**CLIFF LAKE DAM**

**INVENTORY NO. N.Y. 584**

**PHASE I INSPECTION REPORT  
NATIONAL DAM SAFETY PROGRAM**

PHASE 1 INSPECTION REPORT  
NATIONAL DAM SAFETY PROGRAM  
CLIFF LAKE DAM, I.D. NO. NY 584  
DEC #148D-1133  
DELAWARE RIVER BASIN  
SULLIVAN COUNTY, NEW YORK

Spillway  
Note Deteriorated Concrete  
Photo #3 A&B

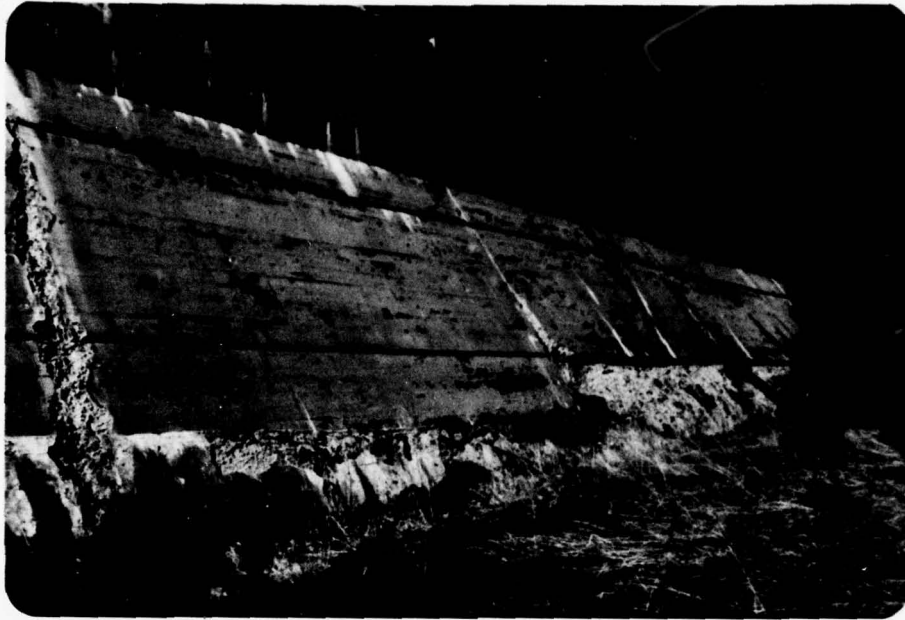
Surface spalling of concrete was evident particularly at the construction joints. The wingwalls are cracked and deteriorated. Hairline cracks were noted in the spillway concrete. A 1-inch opening was observed at the contact of the spillway toe and the apron. No indication of recent movement and no seepage was observed. (See Photo #3) A 2-inch diameter pipe was protruding from the spillway; purpose unknown. Two rectangular drains were noted at the base of the spillway. (See Photo #4) These drains provide relief of seepage and uplift forces beneath the spillway and non-overflow sections (See sketch Appendix C, Section 6, and Appendix G, Drawings #1300-56 and 1300-57 for drain details). Seepage from these drains was clear and estimated to be 5 gpm from the west drain and 8 to 10 gpm from the east drain. Approximately 1 gpm was evident seeping from the east wingwall drain. These drains are partially blocked with debris and vegetation. The area behind this wingwall is soft and wet with vegetation present having an affinity for water (See Photo #3B).

1. Significant deterioration of concrete particularly at the construction joints require repair.

Deteriorated Panel Non-overflow Section  
Note Depression at Toe  
Photo #7

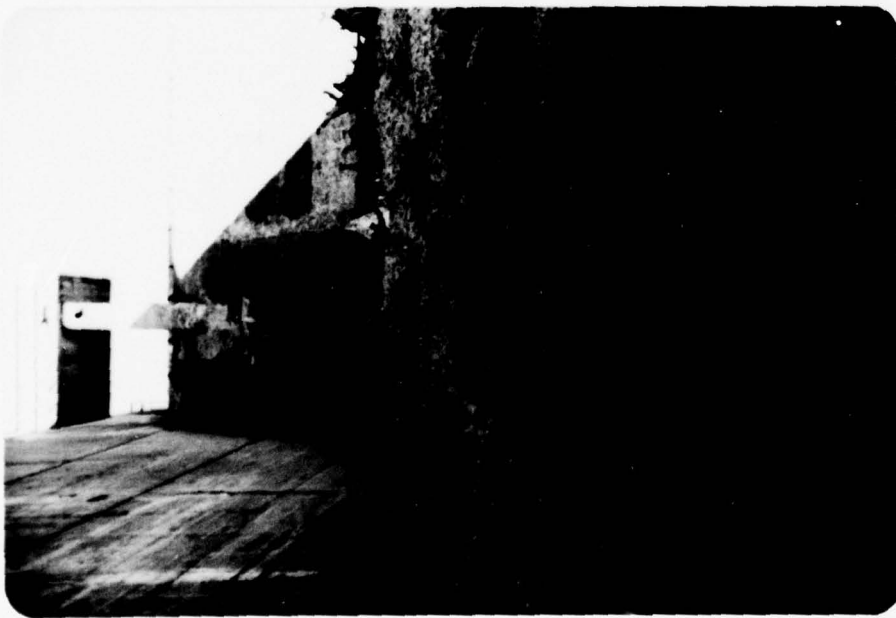
Surface spalling, calcification, and deterioration was evident in the non-overflow section of the dam particularly at the construction joints, along the top of this section and at the east wingwall of the spillway (See Photos #5, 6, & 7). Surface spalling on the eastern most panel of the downstream face was 2 to 3 inches (Photo #7); on the upstream face spalling was approximately 6 inches at the western most construction joint. Numerous hairline cracks were evident, and 2 of the vertical shear keys at the construction joints had hairline cracks through the shear key, indicating reduced strength of the key. A large depression at the base of the non-overflow section was observed (See Photo #7). The size of the depression was 28 feet long, 5 feet wide, and 3 feet deep. The origin of the depression is unknown. No evidence of seepage or erosive

force was apparent, which would be needed to create this depression. This area may have been the remnants of construction excavation, or post construction excavation to clear the foundation drain outlets.

1. Significant deterioration of concrete of the non-overflow section should be repaired.
2. Investigate the condition of the shear keys to determine if the necessary strength is available to resist the shear forces.
3. Investigate the area at the toe of this section to determine the condition of the foundation drain outlets and the large depression. Drains should be kept free of debris and an outlet of sufficient capacity installed and maintained to assess the conditions of seepage and uplift beneath the dam.
4. Seepage observed exiting from behind the east spillway abutment should be investigated. This may be related to the adjacent foundation drain system.

Reservoir Drain and Controls  
Note Deteriorated Concrete and Exposed Reinforcing  
Photo #8

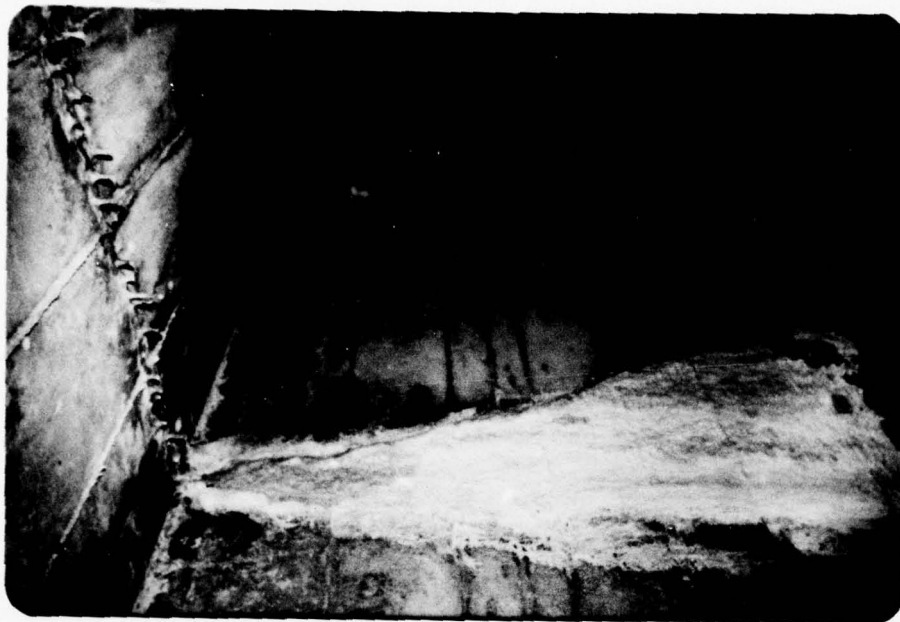
The concrete at the drain is deteriorated at the outlet with reinforcing bars exposed. Slight seepage and calcification was evident in the walls of the drain initiating from the joint between the top and walls of the box drain. (See Photos #8 & 9) the concrete slab at the west end of the spillway channel which covers the reservoir drain is deteriorated and some reinforcing is exposed. Surface spalling was noted particularly at the construction joints.

1. Repair the deteriorated concrete of the reservoir drain. Repair the construction joints within the drain.

Outlet Channel Below Spillway  
Photo #14

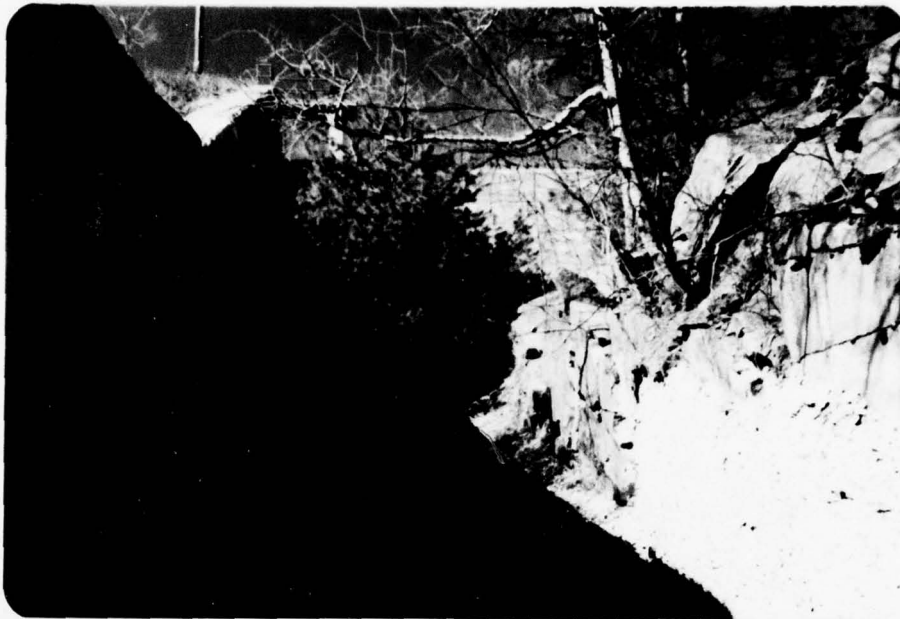
Seepage from spillway area flows into a narrow outlet channel. This channel is formed from the natural bedrock, and the west spillway wingwall seepage was rusty, and deposits of rust were evident in the spillway and outlet channels. (See Photos #14 & 16)

Considerable tree growth and debris was observed in the outlet channel and spillway channel. An access bridge also constricts the spillway flow below the dam. (See Photo #15) The outlet channel is extremely narrow and overtopping of the channel walls may result during high flow conditions.

2. The foundations drains should be cleaned of debris and vegetation, and monitored periodically to determine the influence of seepage and uplift.
3. Remove tree, vegetative growth and other debris in the spillway channel, at the abutments and along the tailrace channel.
4. Investigate the condition of the narrow outlet channel to determine if sufficient capacity exists within the channel to pass the  $\frac{1}{2}$  PMF, without overtopping of the channel or damage to the earth embankment portions of the dam.
